APPLICATION FOR A RESIDENTIAL SITE IMPROVEMENT PERMIT/ CONSTRUCTION AUTHORIZATION FOR AN ON-SITE WASTEWATER SYSTEM, NEW WELL INSTALLATION, OR REPAIR OF EXISTING WELL

SOIL/SITE EVALUATION
for ON-SITE WASTEWATER SYSTEM

IMPROVEMENT PERMIT DENIAL

Re: Application for Improvement Permit for property located at 4509 WOODLAND AV , MINT HILL, NC 28227
Parcel No.: 13711270
Health Department File No.: SP26-097

SITE PLAN

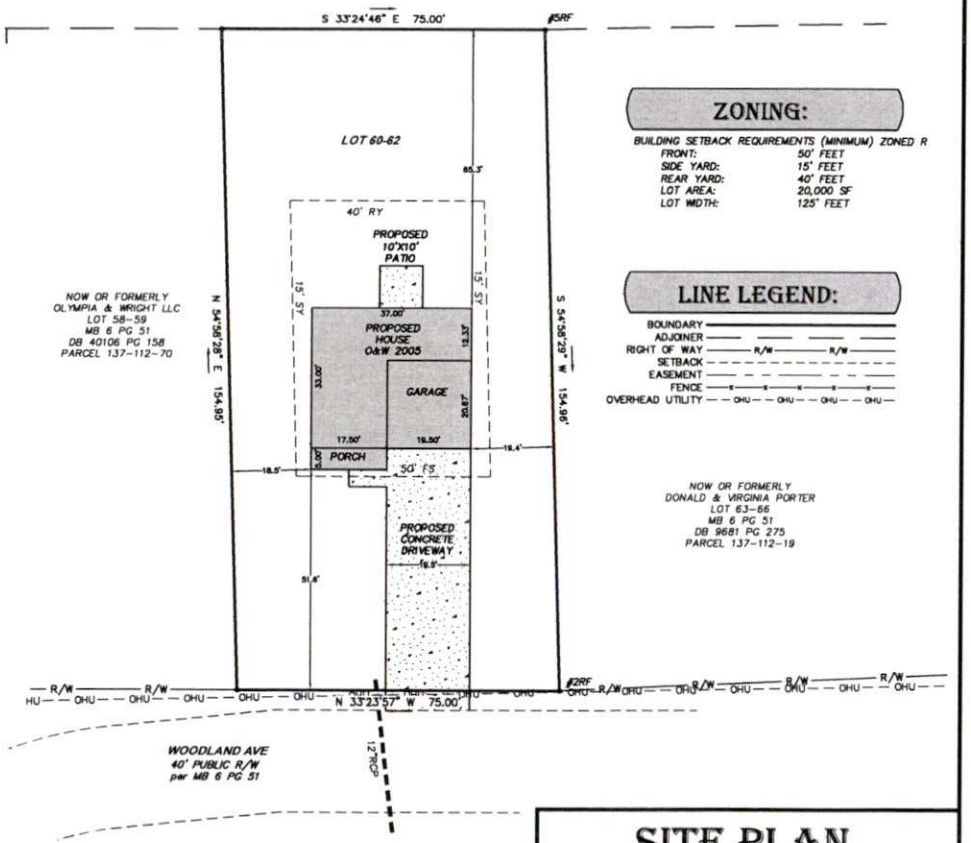
COMMENTS: There is insufficient space for a 5 BR SFR initial system and repair area with a design LTAR of 0.30.

Based on the criteria set out in 15A NCAC 18E .0501 through .0602, the evaluation indicated that the site is **UNSUITABLE** for an on-site wastewater system. Therefore, we must deny your request for an Improvement Permit. A copy of the site evaluation is enclosed. The site is unsuitable based on the following:
